CERTIFICATE OF APPROPRIATENESS

Property: 1832 Columbia Street, lot 20, block 108, Houston Heights Subdivision. The property includes a historic 1,036 square foot historic residence situated on a 6,600 square foot (50' x 132') interior lot.

Proposal: Alteration – Construct a two story 1,764 square foot addition and attached two story rear garage with 400 square feet of living space to the rear of a one story contributing residence.

Recommendation: Denial – Does not satisfy criteria 1, 4, 8, and 9

PROPOSED DEMOLITION PLAN

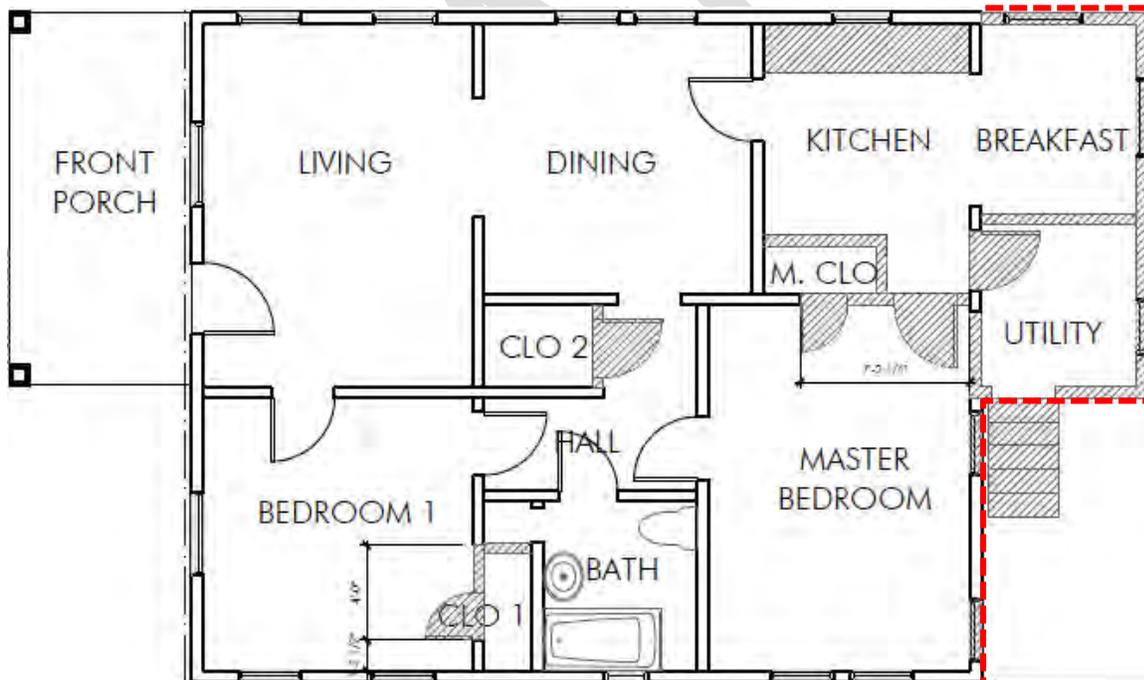
<i>The proposal to locate a portion of the addition on top of the existing structure jeopardizes its essential form and integrity. The existing wall material often needs to be replaced or heavily altered in order to carry the added load of the second story.</i> |
